County of Loudoun
Department of Planning
MEMORANDUM

SUBJECT: Addendum to ZMAP 2008-0021, Kincora Village Center, Third Referral

County of Loudoun
Department of Planning
MEMORANDUM

STREET SECTION I

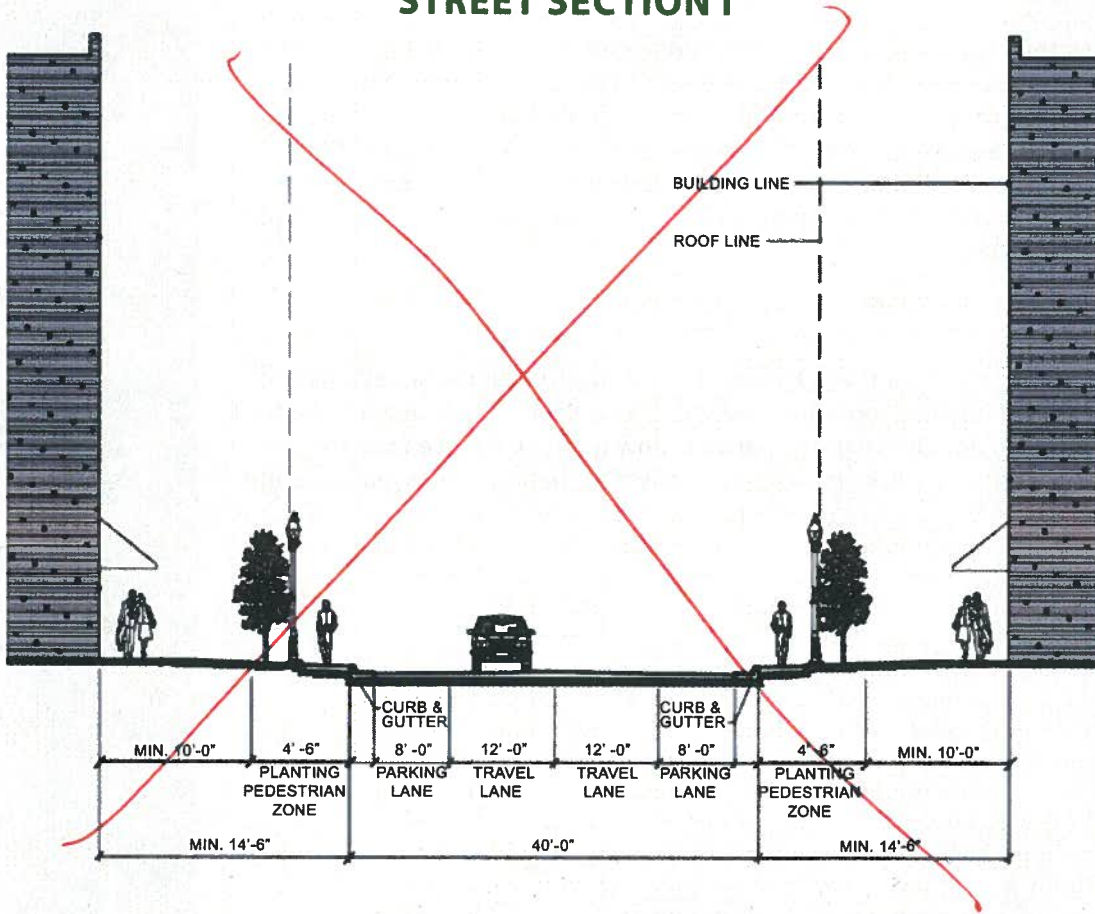
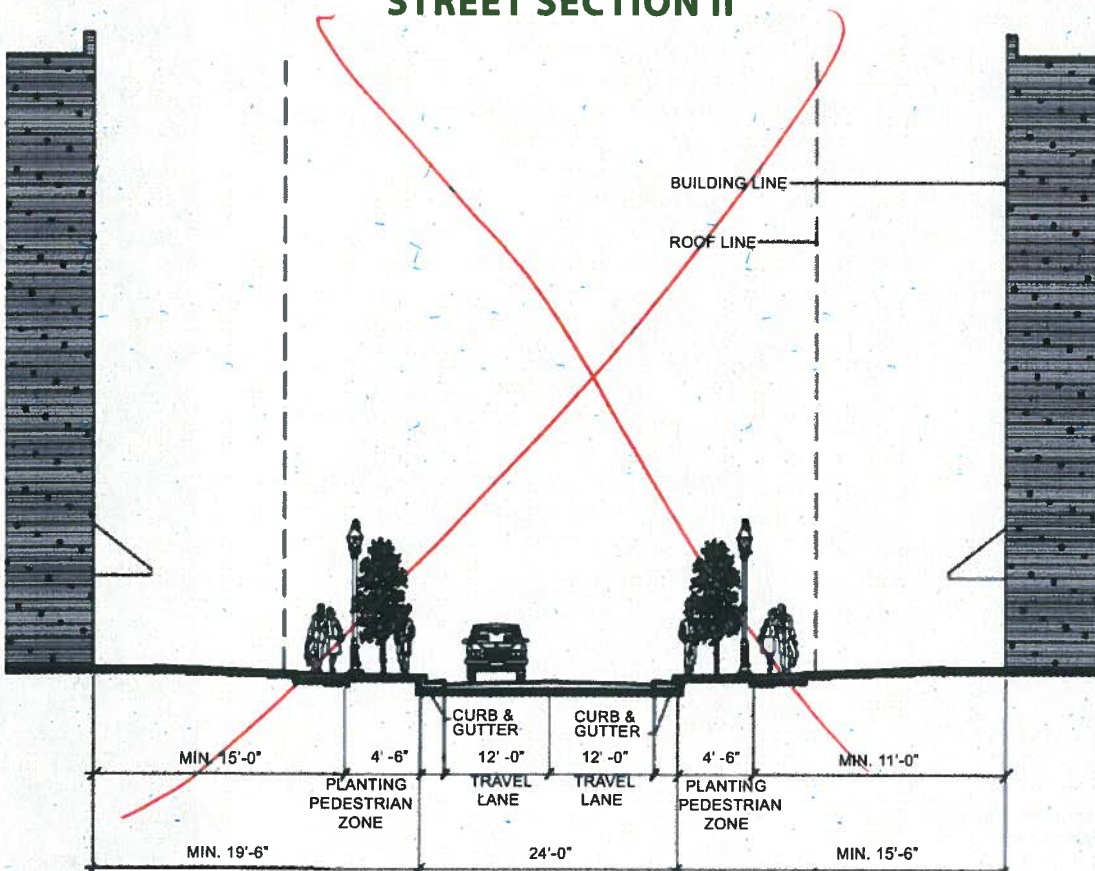
Street sections 18 II below are not consistent with the Typical Sections provided on Sheet 18 of the CDP.
